# Access Compliance Report

## Public Rights-of-Way

### (Curb Ramps)

Intersection ID: 25357	Main Street: RAINTREE_LN	Cross Street: WILLOW_POINT_DR	Location: NE
ADA ID: D1F262FF18DF	Ramp Type: Perp	Initial Pass/Fail: Fail	Overall Compliance: No
		Severity Score: 1.25

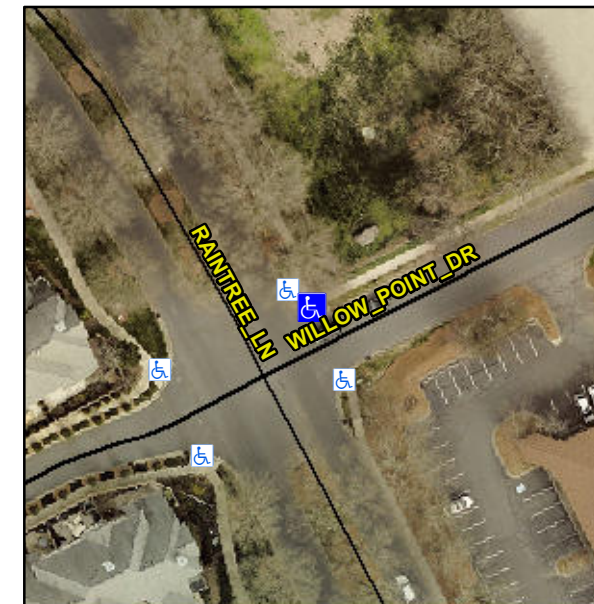
**Not Found, R304.5.3**

Compliance	Description	Data	Compliance	Description	Data
N/A	Ramp Length (in)	60.0	Yes	Ramp Slope (%)	7.3
Yes	Ramp Width (in)	51.0	No	Ramp XSlope (%)	2.7
N/A	Flare Type LT	N/A	N/A	Flare Type RT	N/A
N/A	Flare Slope LT (%)	N/A	N/A	Flare Slope RT (%)	N/A
N/A	Flare Traversable LT?	N/A	N/A	Flare Traversable RT?	N/A
N/A	Landing Length (in)	N/A	N/A	DWS Provided?	N/A
N/A	Landing Width (in)	N/A	N/A	DWS Contrast?	N/A
N/A	Landing Slope (%)	N/A	N/A	DWS Length (in)	N/A
N/A	Landing X Slope (%)	N/A	N/A	DWS Full Width?	N/A
N/A	Landing Curb? (Y/N)	N/A	N/A	DWS Offset (in)	N/A
N/A	Shared Landing?	N/A			
N/A	Gutter Ponding?	N/A	N/A	Gutter Slope (%)	N/A
N/A	Gutter Lip Ht (in)	N/A	N/A	Gutter X Slope (%)	N/A
N/A	Painted X Walk1?	No	N/A	Painted X Walk2?	N/A
	X Walk 1 Direction	To SE		X Walk 2 Direction	N/A
N/A	X Walk 1 Width (in)	N/A	N/A	X Walk 2 Width (in)	N/A
	X Walk 1 Slope (%)	1.1		X Walk 2 Slope (%)	N/A
	X Walk 1 X Slope (%)	2.3		X Walk 2 X Slope (%)	N/A

**Remove & Replace Entire Ramp.**
